ACEA observations – Low speed WLTP cycle part:

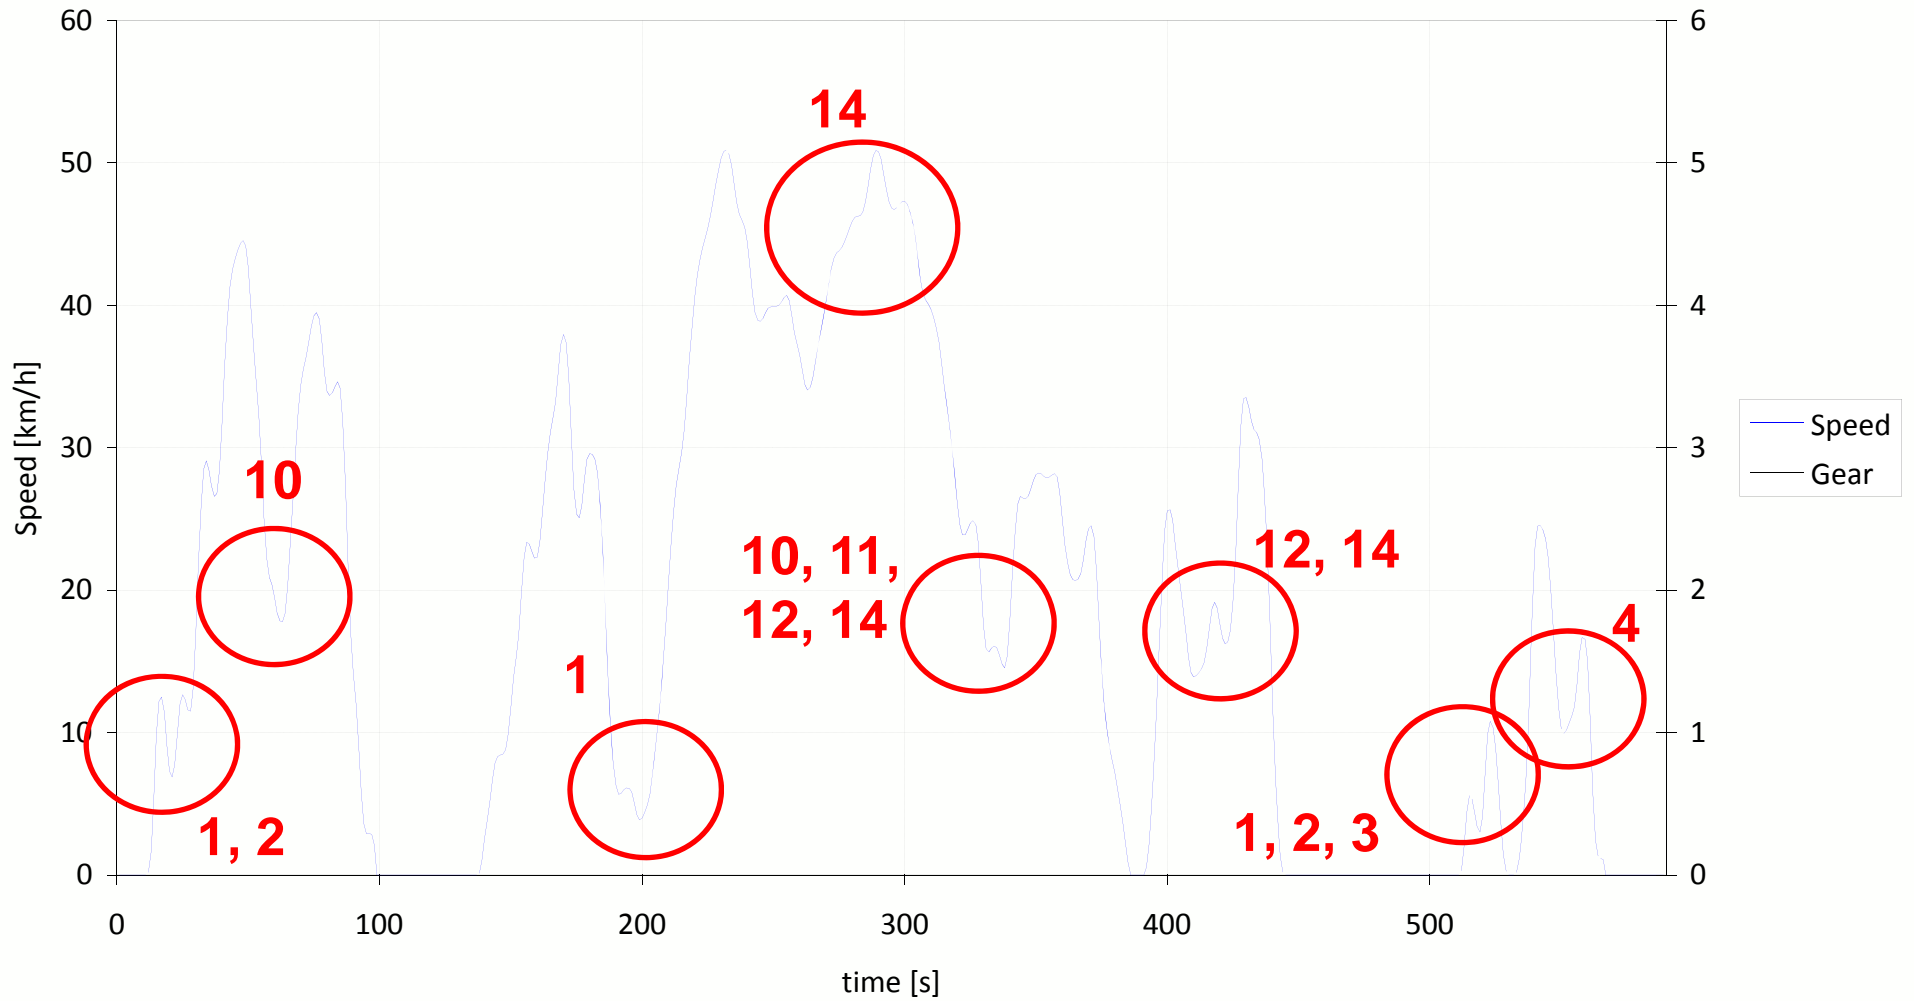
Concern #	Vehicle	Gear Shift	Vehicle Condition	Test series #	Comments				Remarks
					Low	Middle	High	Ex-High	
1					15s, 200s, 520s	665s	1061s, 1153s		Driving at v <12 km/h could be avoided in order to reduce variability. Low engine speed. <u>must slip clutch.</u>
2					15s, 520s	890s	1080s, 1270s, 1363s	1560s, 1640s, 1730s	Micro transients tempting to cut corners
3					520s				Short trip should be replaced
4					553s	665s	1382s		Busy driving: accel, shift gear - decel. Timing is difficult.
5								1490s, 1520s	Hard acceleration. Cannot follow cycle. Gear shift schedule and/or cycle needs to be adapted.
6							1165s		Hard acceleration. Possible torque steer effect. Gear shift schedule and/or cycle needs to be adapted.
7						793s	1146s, 1382s		Transition from acceleration to sharp deceleration difficult to follow (auto gearbox)
8						665s	1061s		Transition from sharp deceleration to acceleration at very low speed difficult to drive

ACEA observations – Mid speed WLTP cycle part:

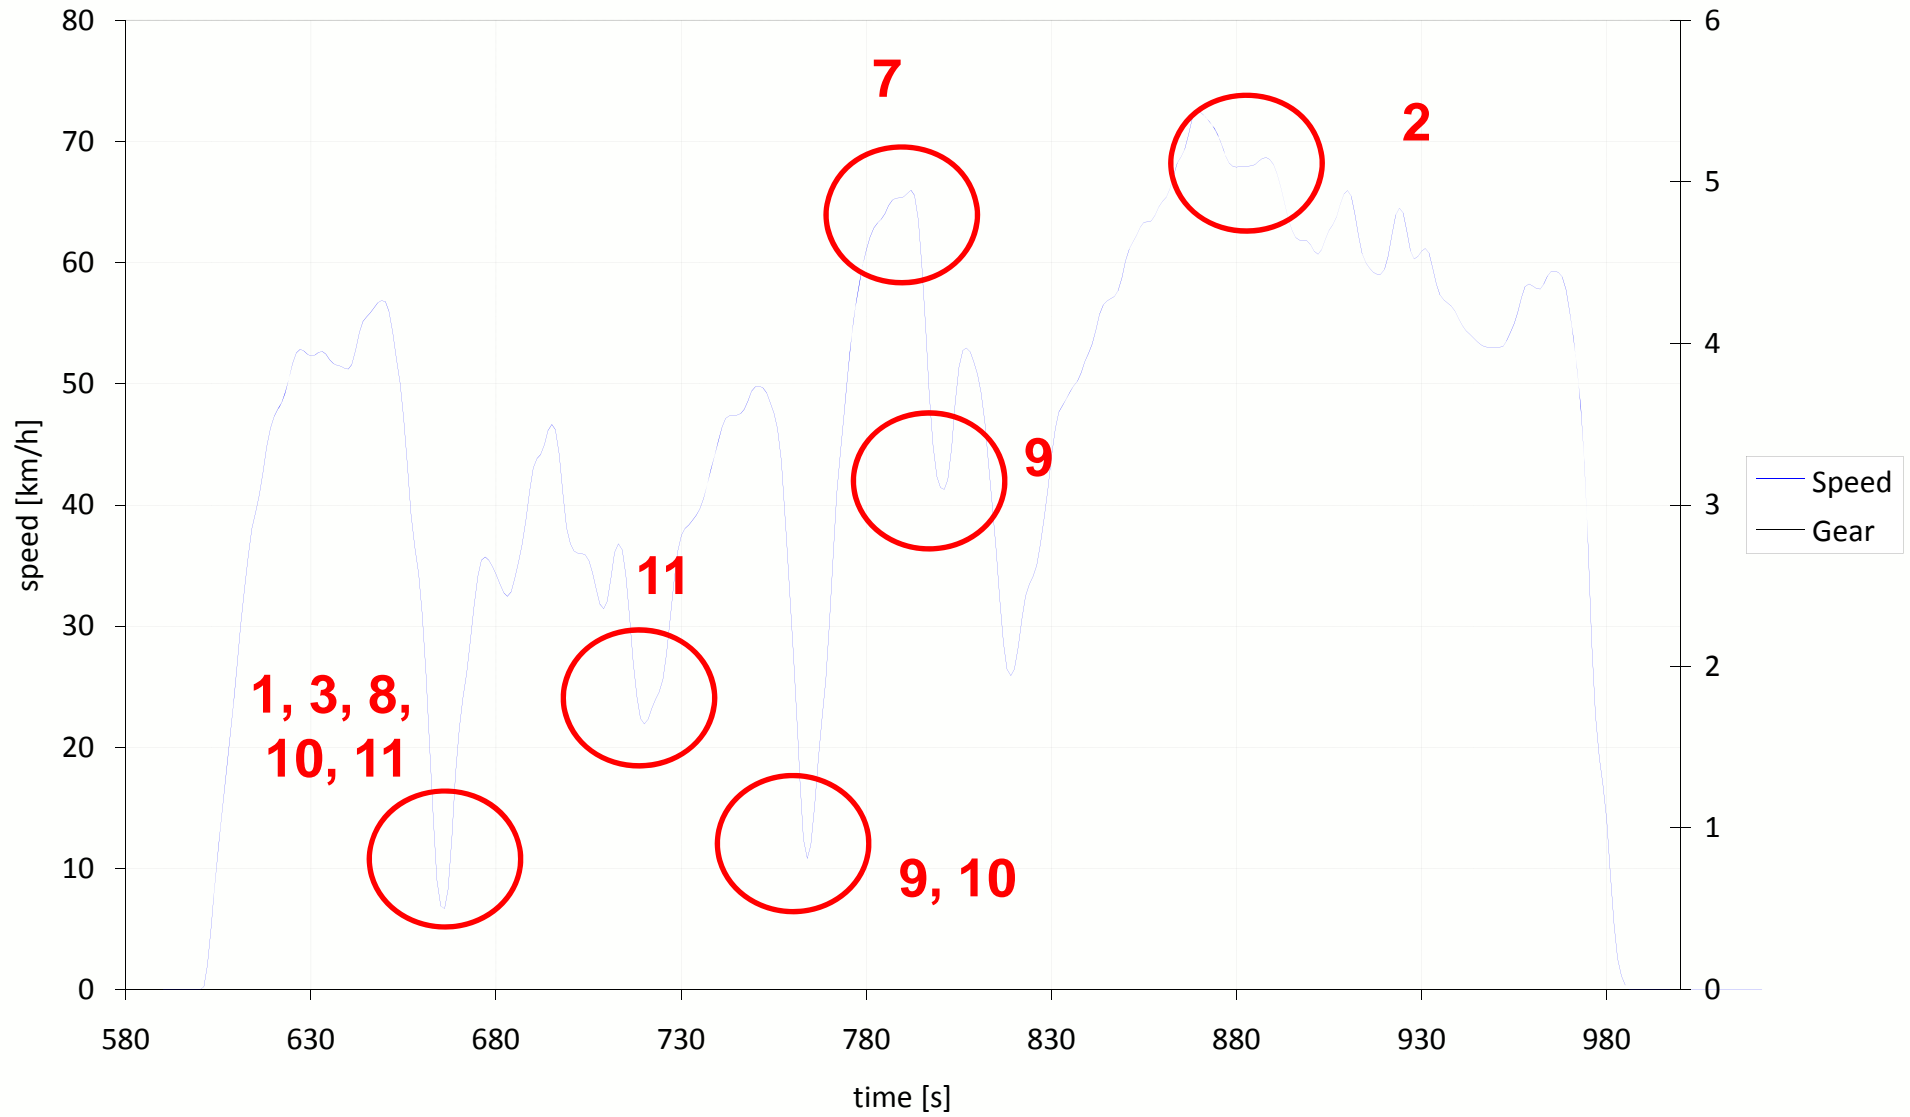
9						765s, 800s			Transition from sharp deceleration to acceleration difficult to drive

ACEA observations – High speed WLTP cycle part:

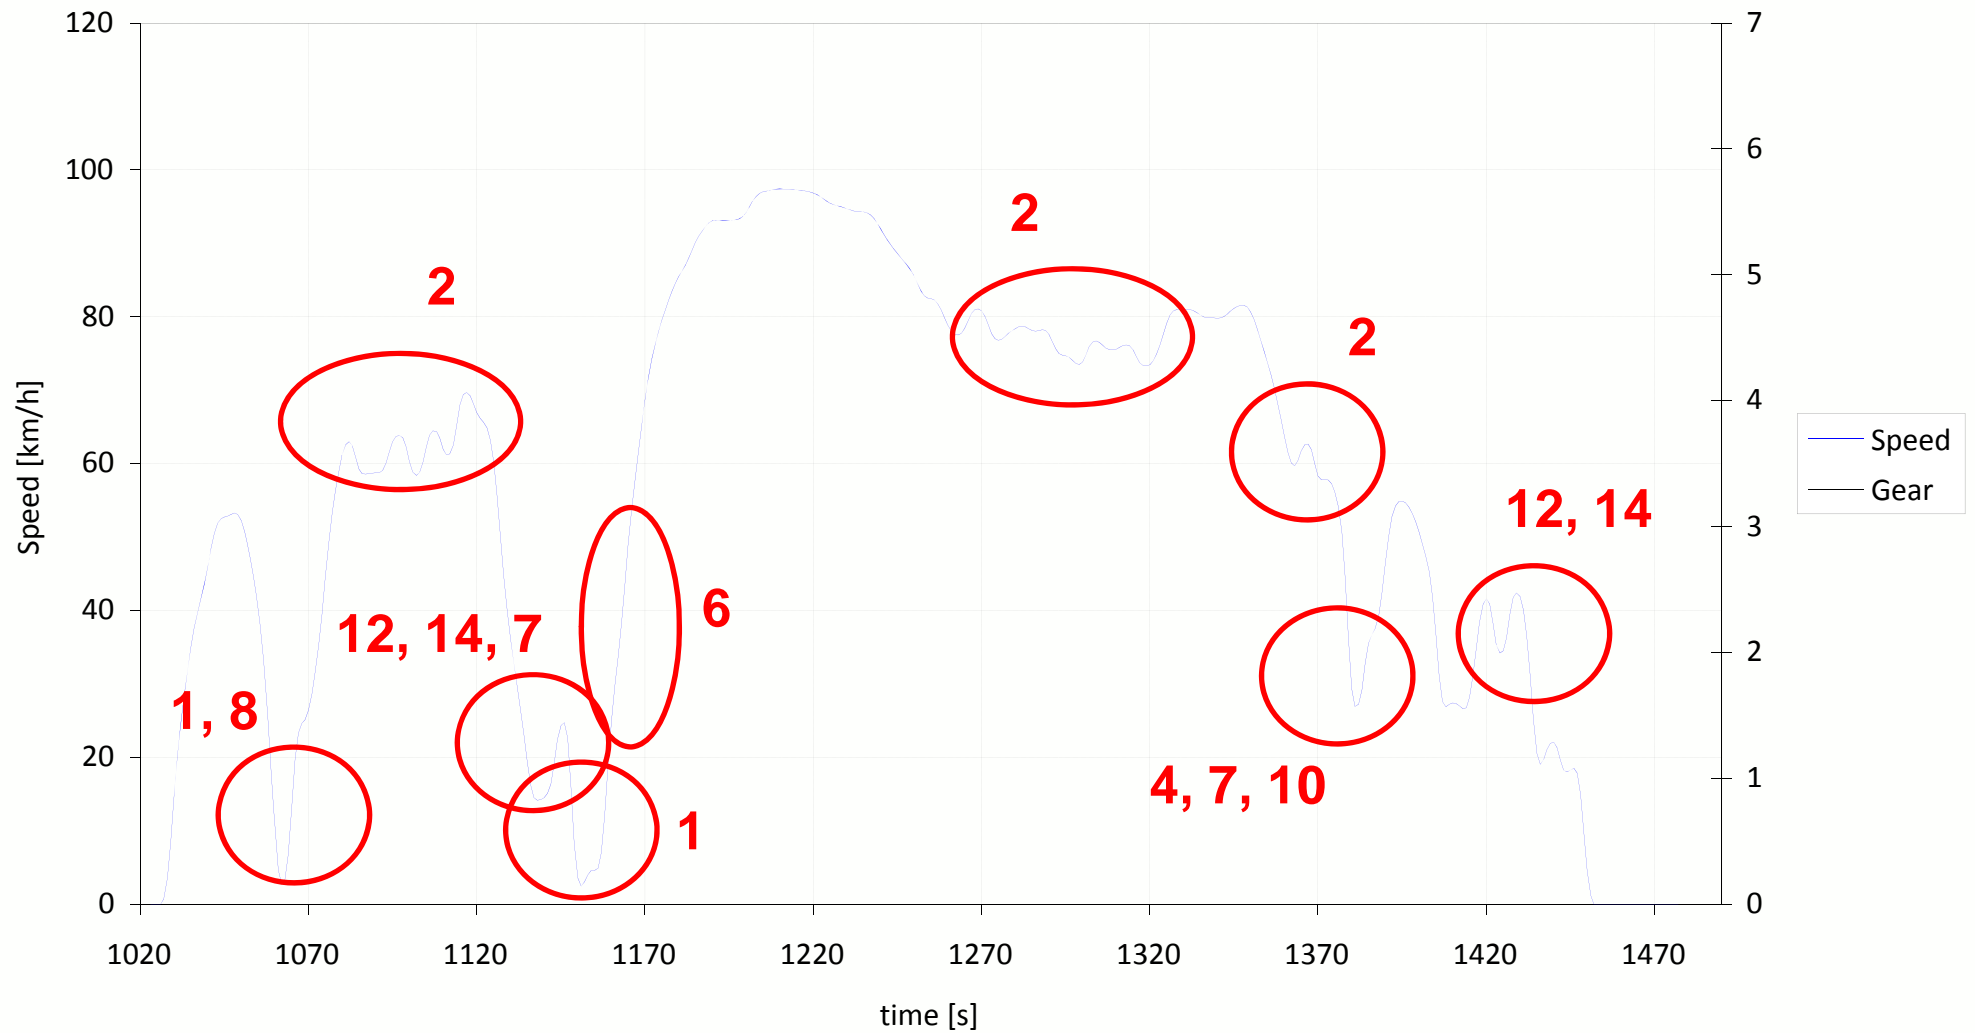
10		Japan			63s, 340s		1382s		Down shift in transition from decel to accel should be avoided. Down shift before transition to allow
11		Steven			63s, 340s	665s, 720s			Down shift in transition from decel to accel should be avoided. Down shift before transition to allow engine braking.
12		Japan			330s, 412s		1140s, 1440s		Low engine speed
13		Japan							High engine speed
14		Steven			278s, 295s, 330s, 412s		1140s, 1440s		Low engine speed
15		Steven							High engine speed
16		Japan						1520s	Rapid gear changes for LCV
